AMENDMENT OF SOLICITATION/MODIFICATION OF CONTRACT			1. CONTRACT ID CODE	PAGE 1 OF 4 PAGES
2. AMENDMENT/MODIFICATION NO. AMENDMENT NO. 0006	3. EFFECTIVE DATE 7/26/11	4. REQUISITION/PURCHASE REQ. NO.	5. PROJECT NO. (If applicable) 07-0008	
6. ISSUED BY CODE	jsy	7. ADMINISTERED BY (If other than Item 6) CODE See Item 6		
Officer in Charge of Construction MCI-East 1005 Michael Road Camp Lejeune, NC 28547-2521				
8. NAME AND ADDRESS OF CONTRACTOR (No., street, county, State and ZIP Code)		(X)	9A. AMENDMENT OF SOLICITATION NO. N40085-07-R-0008	
		X	9B. DATED (SEE ITEM 11) 7/11/11	
			10A. MODIFICATION OF CONTRACT/ORDER NO.	
			10B. DATED (SEE ITEM 11)	
CODE	FACILITY CODE

Project 07-0008, Replace Chiller, Bldgs 59 & 60, Camp Lejeune, NC

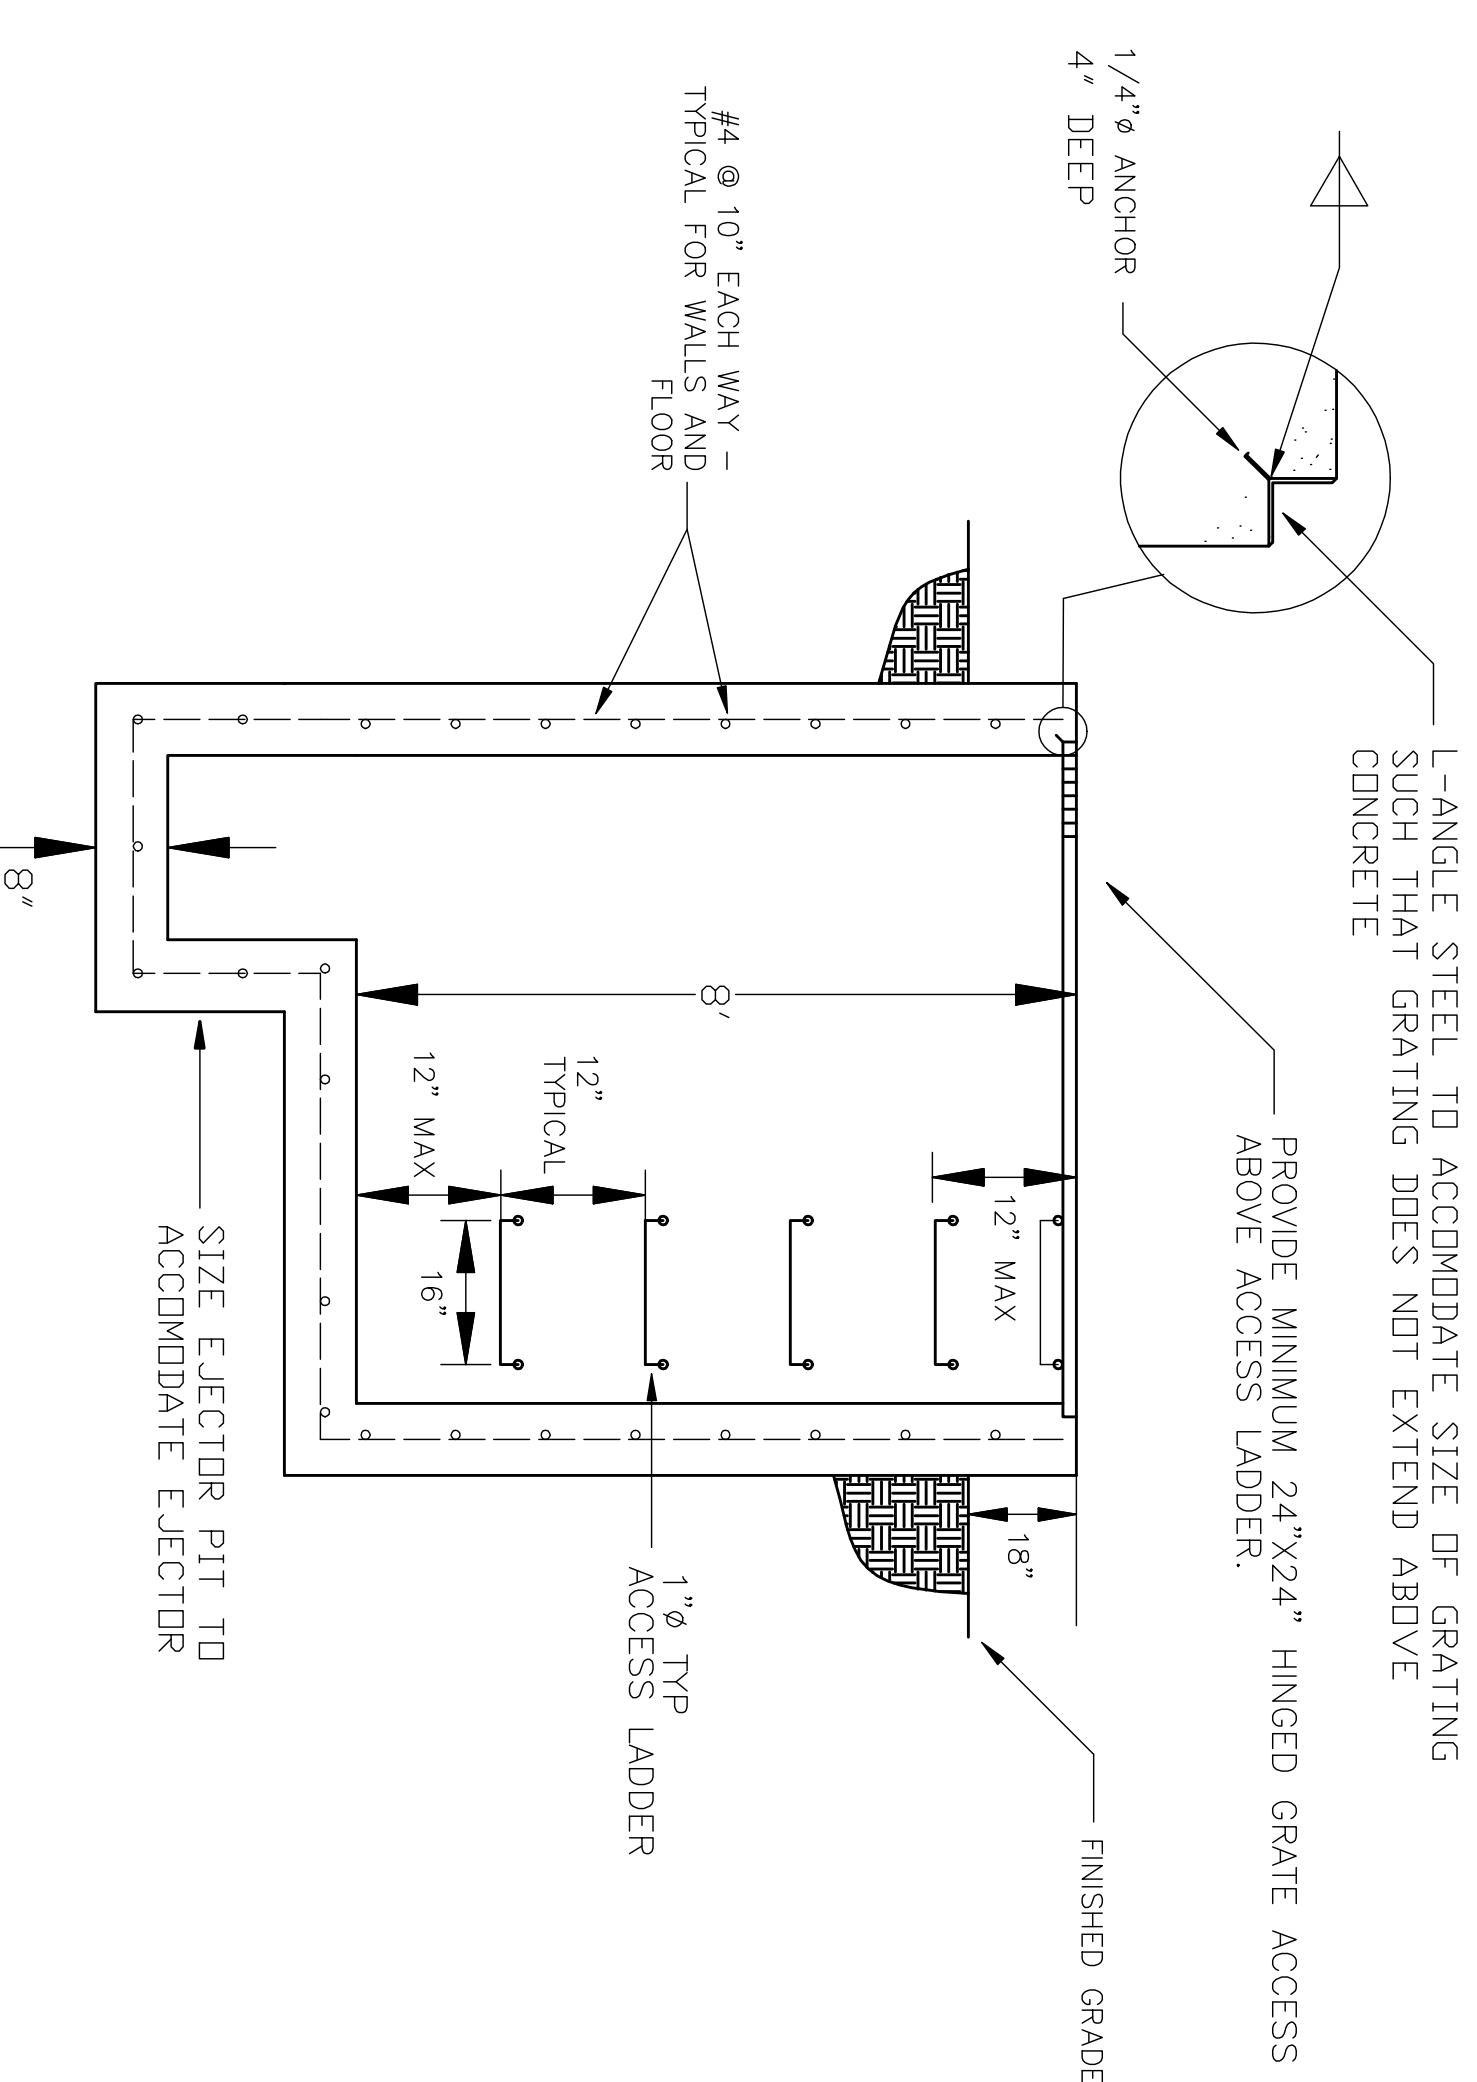
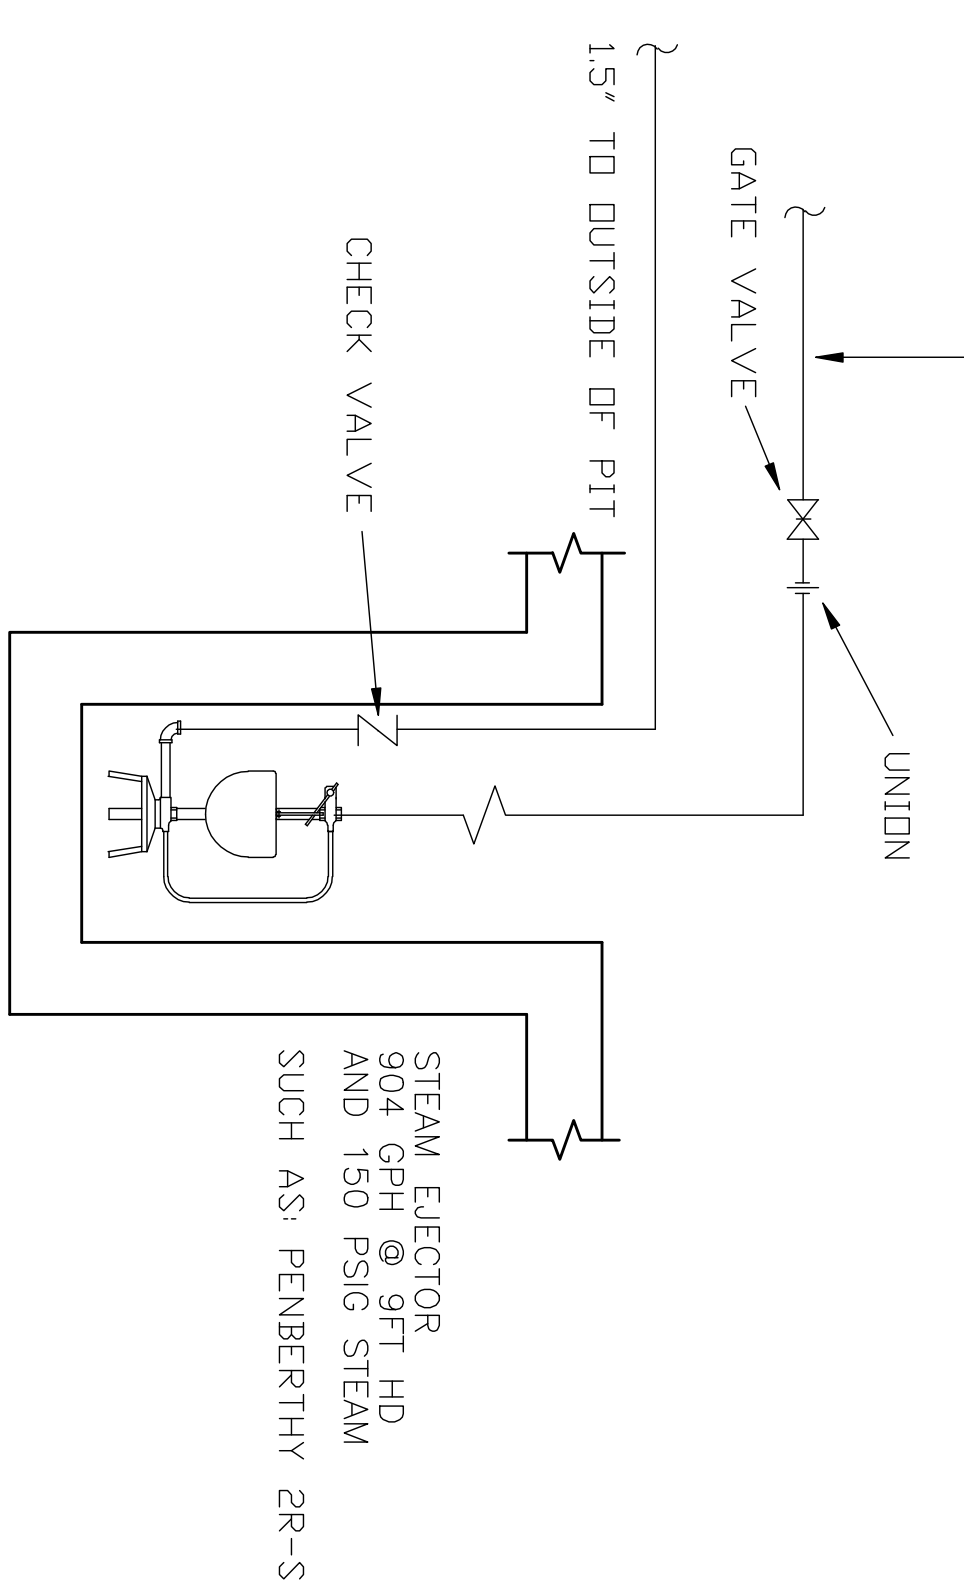
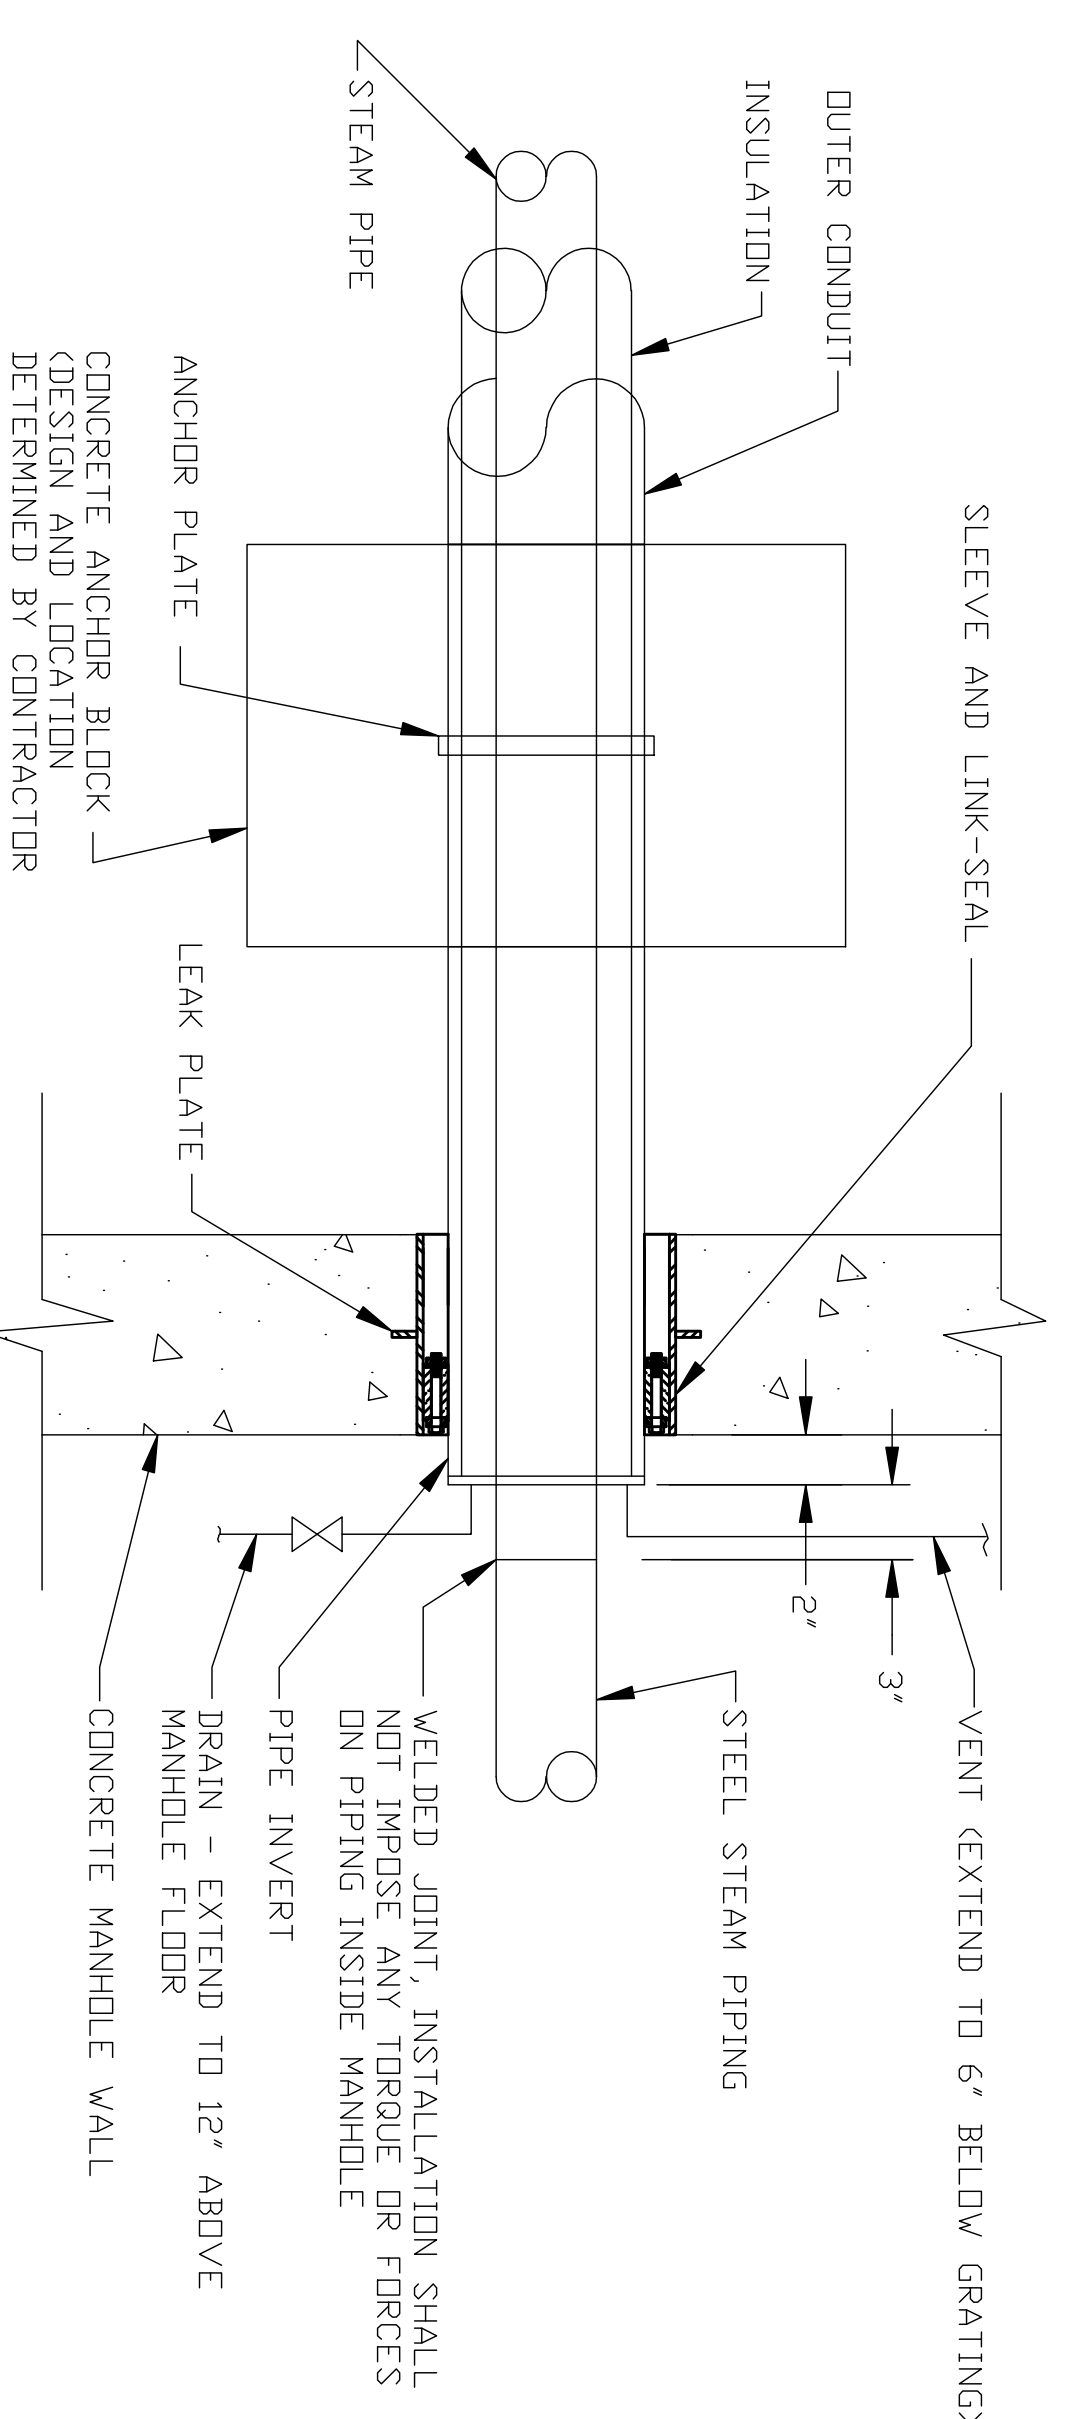
- 1. Question:** Referencing sheet M-1, we are told to provide a concrete "MAN HOLE" with steam operated sump pump, and full grated top. Reading further, the "D" notation indicated in the revisions notes that this is not a man hole, but a "STEAM PIT." Please provide a detail of the steam pit indicating wall thicknesses, depth, size, construction, pump specifications, etc.
- 1. Answer:** Manhole drawing is attached and hereby incorporated into the RFP (Request for Proposals) dated 7/11/11.

PROVIDE GRATING TO COVER ENTIRE OPENING
GRATING LIVE LOAD 125 PSF/CONCENTRATED
LOAD 2000 LBS.

WALLS SHALL BE CONSTRUCTED
OF 3000 PSI CONCRETE AND
REBAR

PROVIDE MINIMUM 24"x24" HINGED GRATE ACCESS
ABOVE ACCESS LADDER.

STEAM EJECTOR
304 GPH @ 8 FT HD
AND 150 PSIG STEAM
SUCH AS: PENBERTHY 2R-S

PAINTED STEEL GATE
BASIS OF DESIGN IS EXISTING GATE AT
CHILLER ENCLOSURE AT BLDG. 1140

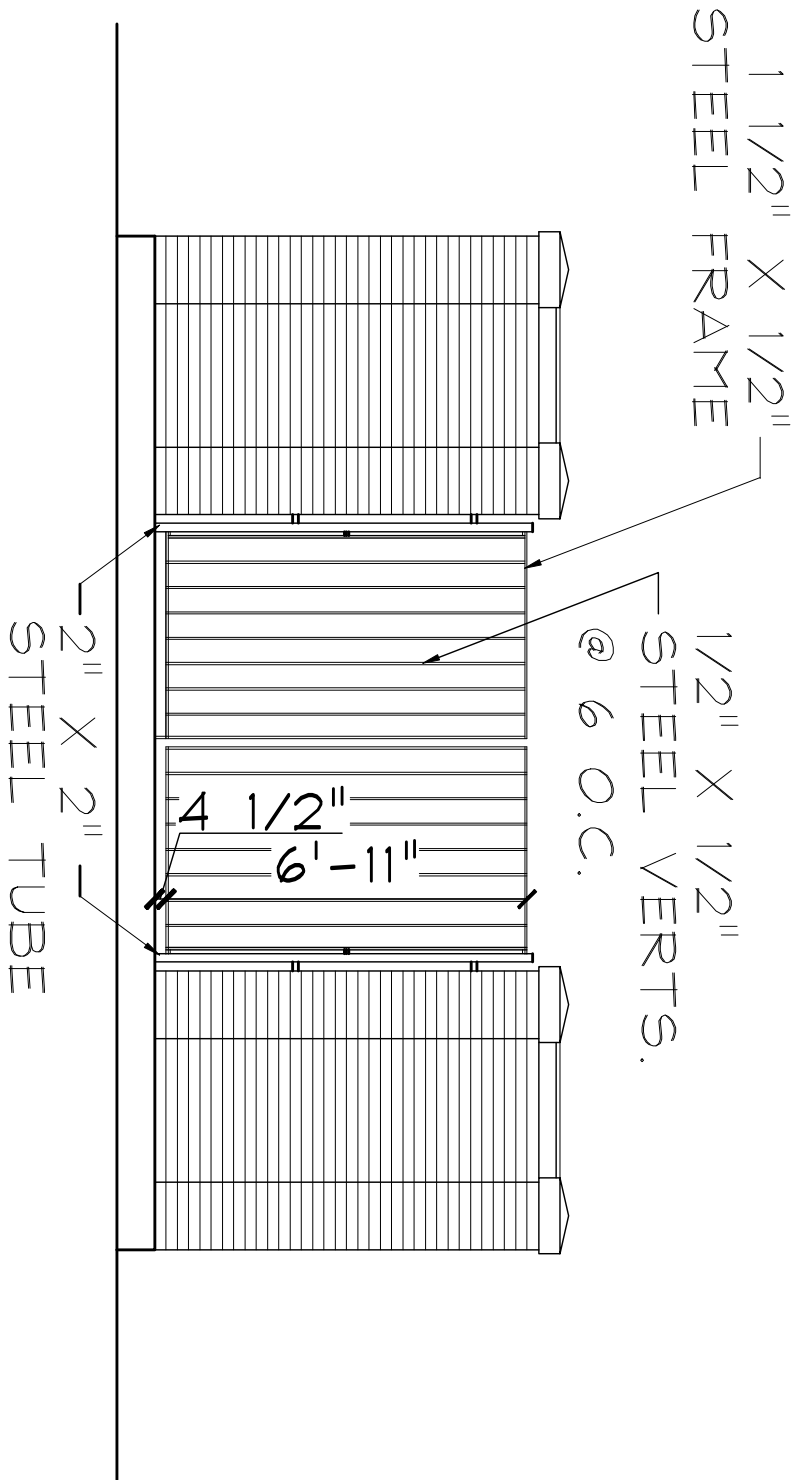
- 2. Question:** Amendment No. 0003 tells us to use a "prefinished aluminum gate" for the chiller enclosure. Due to the expense of aluminum, will a galvanized gate be accepted?
- 2. Answer:** Contractor shall use painted steel in lieu of prefinished aluminum. Steel Gate drawing is attached and hereby incorporated into the RFP (Request for Proposals) dated 7/11/11.
